RANCHO SANTA FE FIRE STATION NO. 6

PROPOSED FLOOR PLAN BUILDING: APPROXIMATELY 2,500 S.F. 01/04/2018

ADDENDUM NO. 02 Station Alerting Wiring Specifications

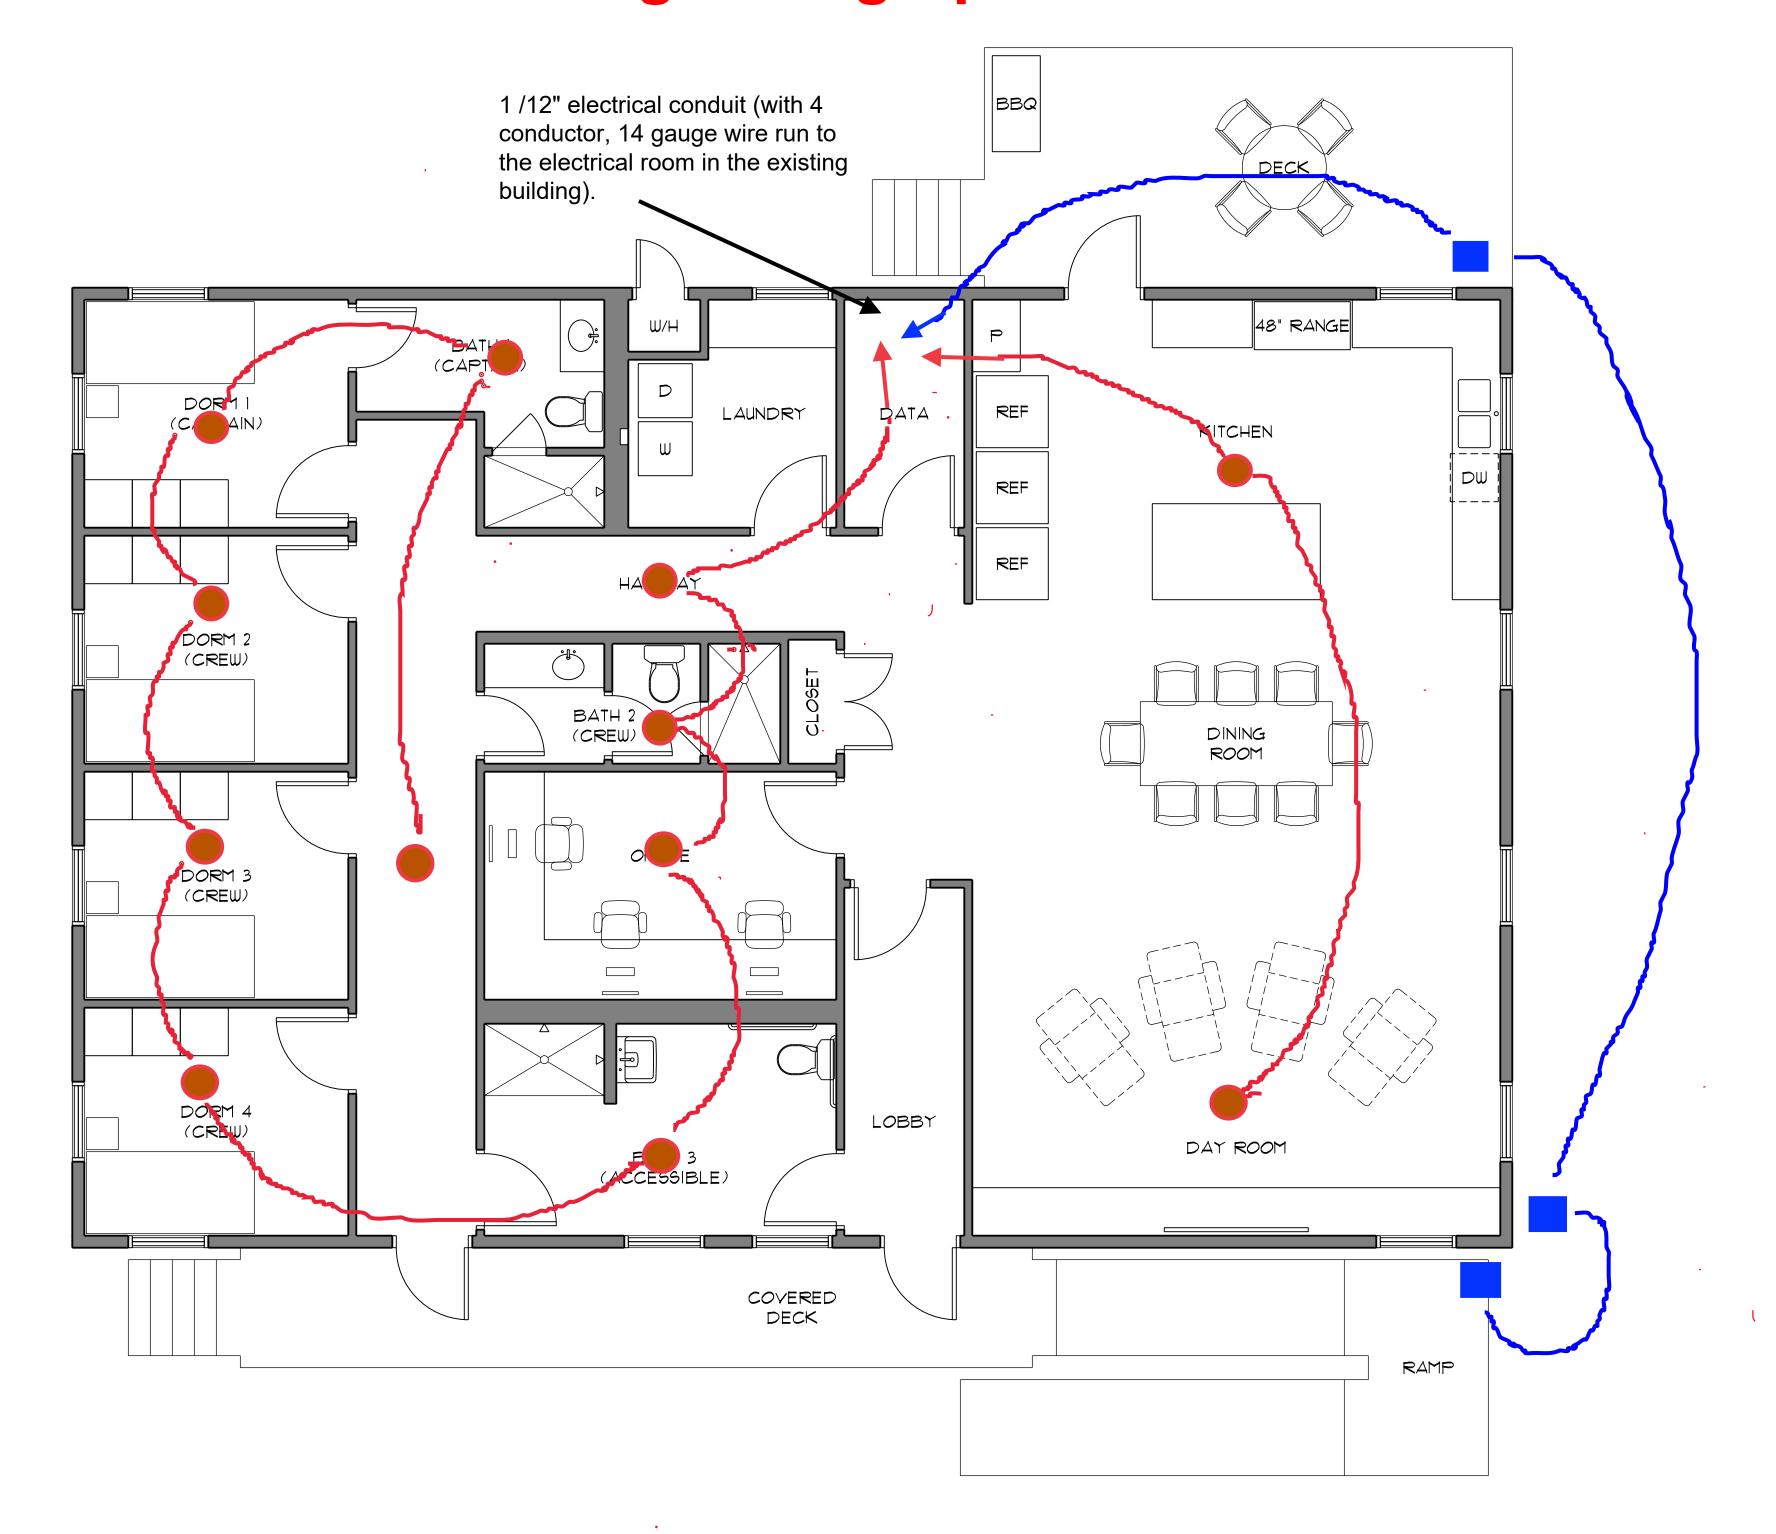
- 2. **Zone 1 Wiring**: Shall have 2 separate wiring circuits (as shown in the drawing) which will run above the ceiling to each of the following interior areas of the new station.
 - a. Dorms 1, 2, 3, 4
 - b. Captains Dorm Bathroom 1
 - c. Bathroom 2
 - d. Bathroom 3

- e. in the hallway next to the dorm room areas
 - f. in the hallway near the laundry room
 - g. Office/Study
 - h. Kitchen
 - i. Day Room

A JBL Bracket (Part No. MTC-24NC) will be blind mounted to the framing above the ceiling as shown in Detail A - Speaker Bracket Installation and Wiring Loop Detail (attached) and within 2 feet on center of room. A 4' wire tail loop (per Detail A) will be accessible so that the vendor can connect the station alerting speakers and lighting.

- 3. Zone 2 Wiring: Shall be run within the exterior walls to three (3) single gang boxes located beneath the eaves on the buildings exterior at the following areas:
 - a. North/East corner, north side
 - b. South/East corner, east side
 - c. South/East corner, south side

All wiring will be pulled to each single gang box as indicated in the floor plan. The vendor will install the exterior speakers directly to each of the single gang boxes.

RANCHO SANTA FE FIRE STATION NO. 6
PROPOSED CONCEPT PERSPECTIVE VIEWS 01/04/2018

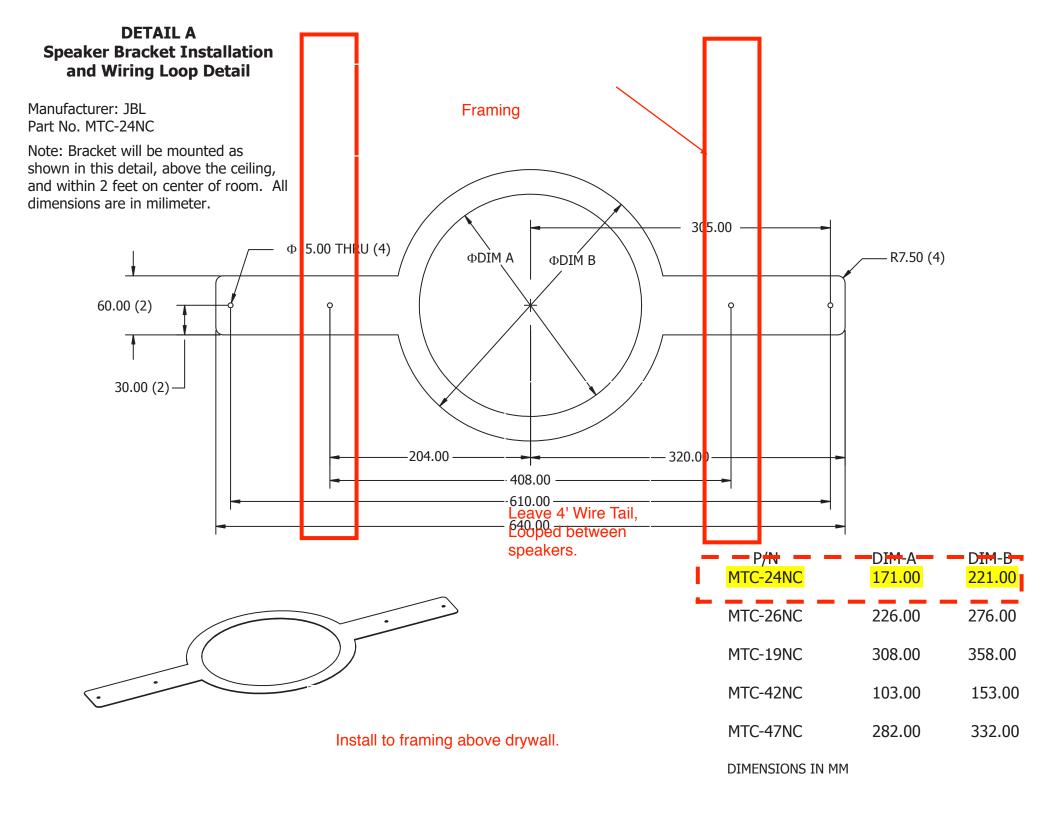
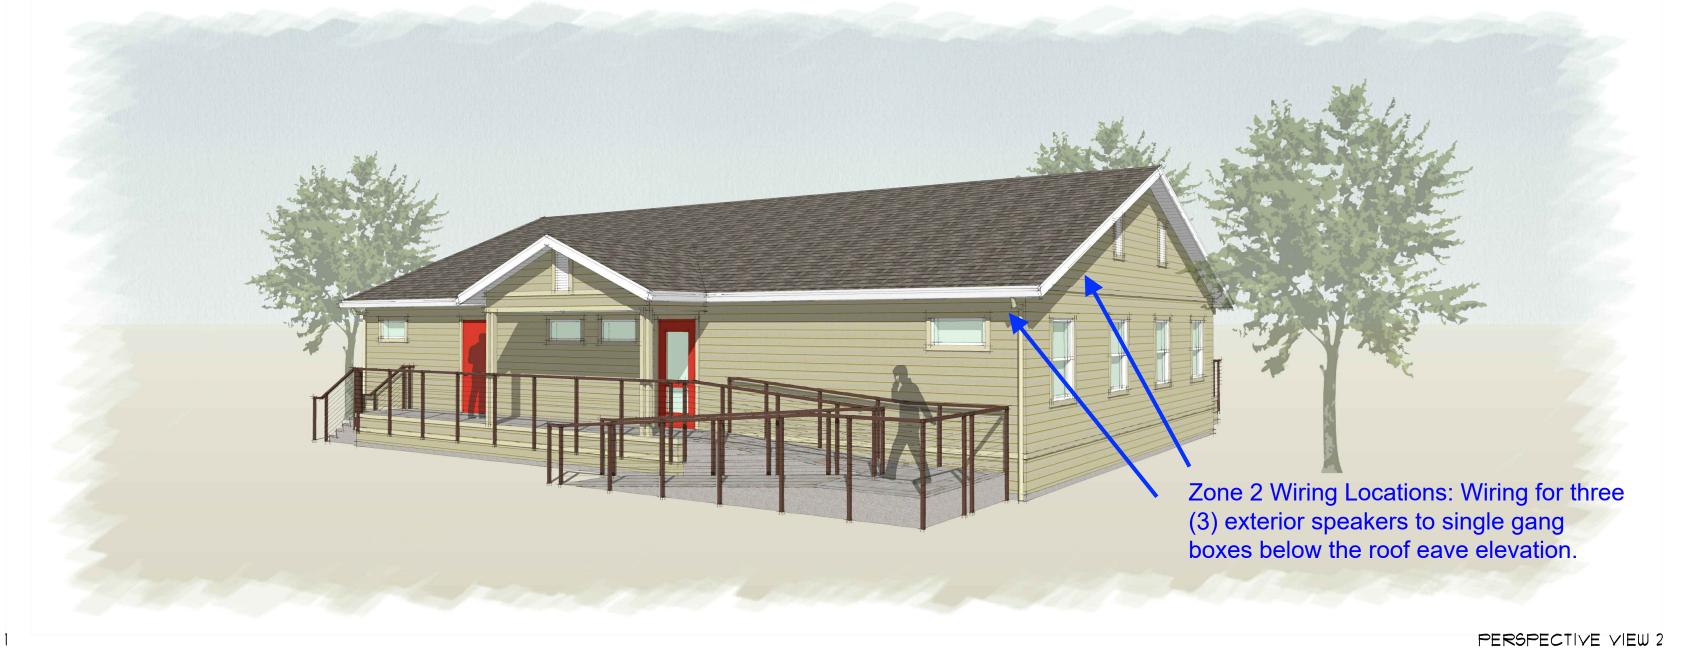
- Zone 1 Wiring Locations: Wiring for twelve (12) alerting system lighting and speakers. See Detail A (next page) for above ceiling bracket and wiring specifications.
- Zone 2 Wiring Locations: Wiring for three (3) exterior speakers to single gang boxes below the roof eave elevation (see last page).
